Modification of Minister's Approval

Elf Substrate Plant and Elf Mushroom Farm Project

MP 08_0255 MOD 1

The modification relates to the Substrate Plant site only and includes:

APPENDIX 2 SUBSTRATE PLANT SITE LAYOUT and STAGES

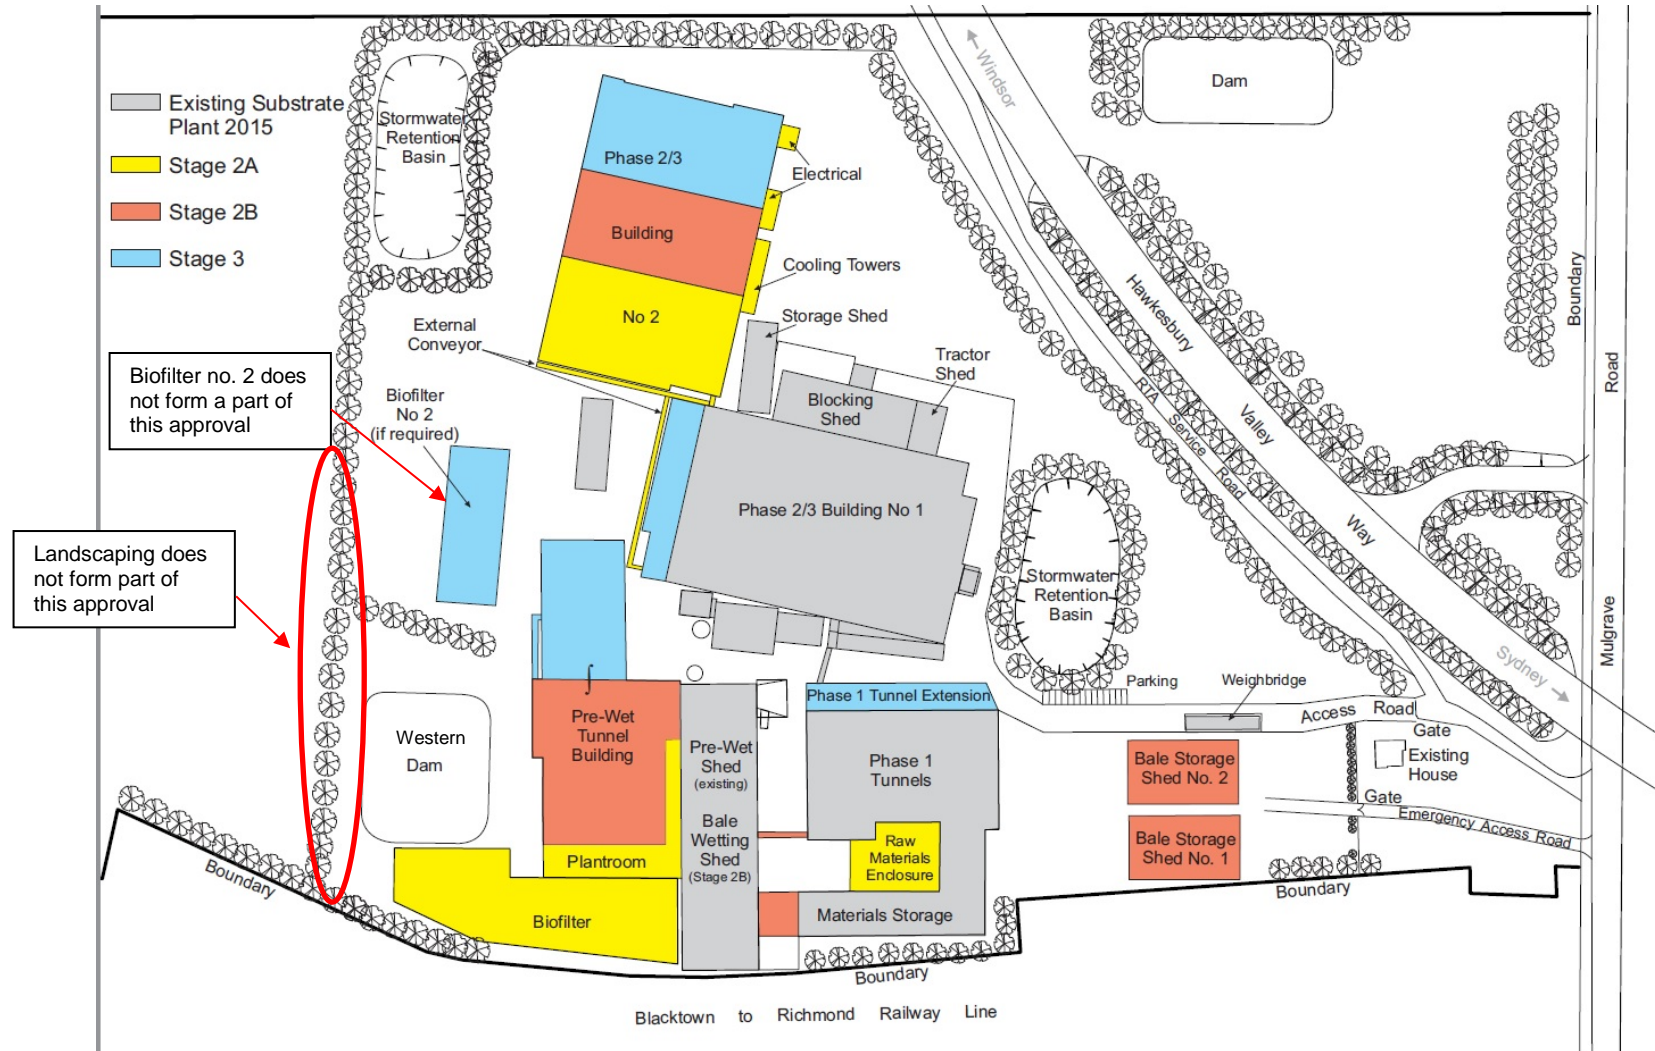
7A Unless otherwise agreed in writing by the Secretary, the Proponent shall ensure that the work associated with MOD 1, with the exception of the additional Phase 2/3 tunnels and the pre-wet tunnels to be constructed as part of Stage 3 (as identified on the plan in Appendix 2), has been constructed and is operating within two years from the date of the approval of MOD 1.
10. Inserting the following new Condition 7B after Condition 7A of Schedule 2:

- 17B The Proponent shall ensure that the western dam at the Substrate Plant site (identified on the plan in Appendix 2 of this approval) does not receive process water.

36. Replacing Appendix 2 with the revised Substrate Plant Site Layout and Stages as shown in Appendix 2.
